Re: EPCOR Natural Gas Limited Partnership ("ENGLP") Southern Bruce Natural Gas Pipeline Project ("Project") – EB-2018-0263 Leave to Construct Application – Minor Change to Pipeline Route

Attachment "A" to Letter to OEB dated December 20, 2019

NPS 6 RELOCATION

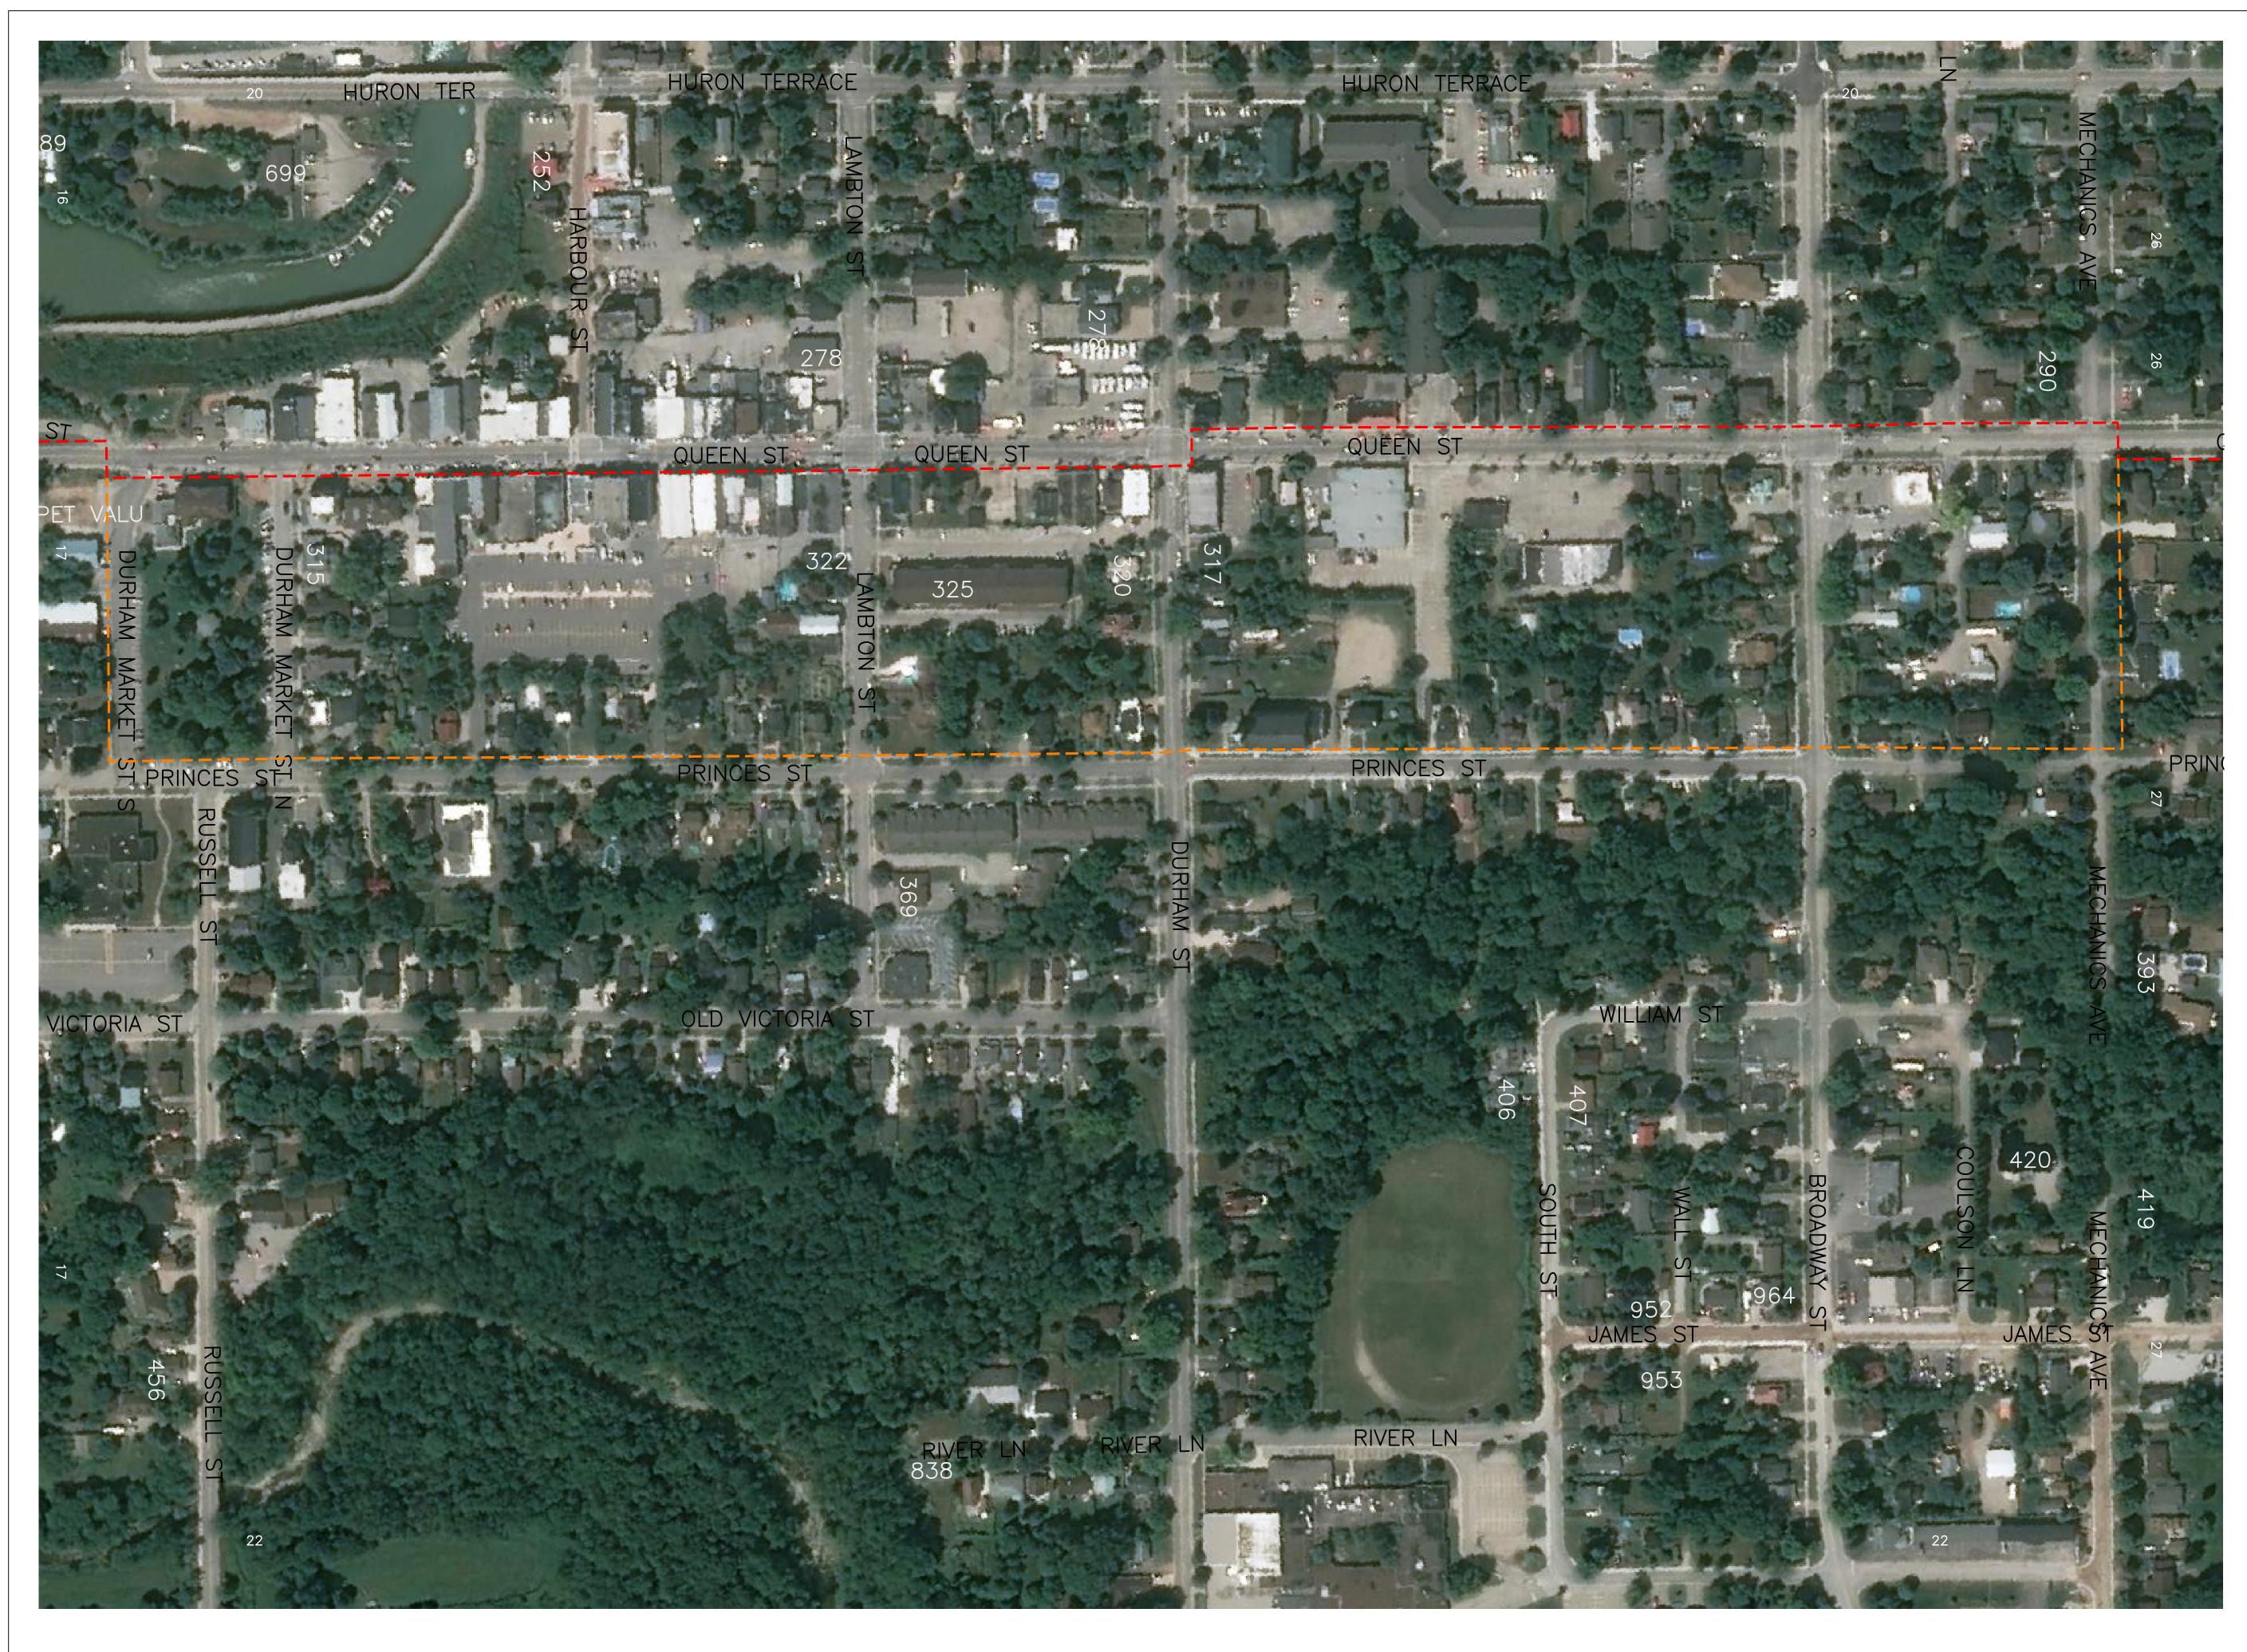
As stated in the evidence for the Project, the plan was to install a 6-inch Medium Density Polyethylene (MDPE) along Queen Street between Mechanics Ave and Durham Market Street South in Kincardine. After further consultation with local utilities it was determined that the Queen Street road allowance is very congested with existing infrastructure.

For this reason, ENGLP is proposing to move the 900 metre portion of the MDPE pipeline one block east along Princes Street, as shown in Attachment A to this letter. The pipeline will be installed within the road allowance, and the relocation of this short section will mitigate

risks and prevent significant interference with respect to underground utilities. This realignment will not impact ENGLP's ability to serve all future customers in the area.
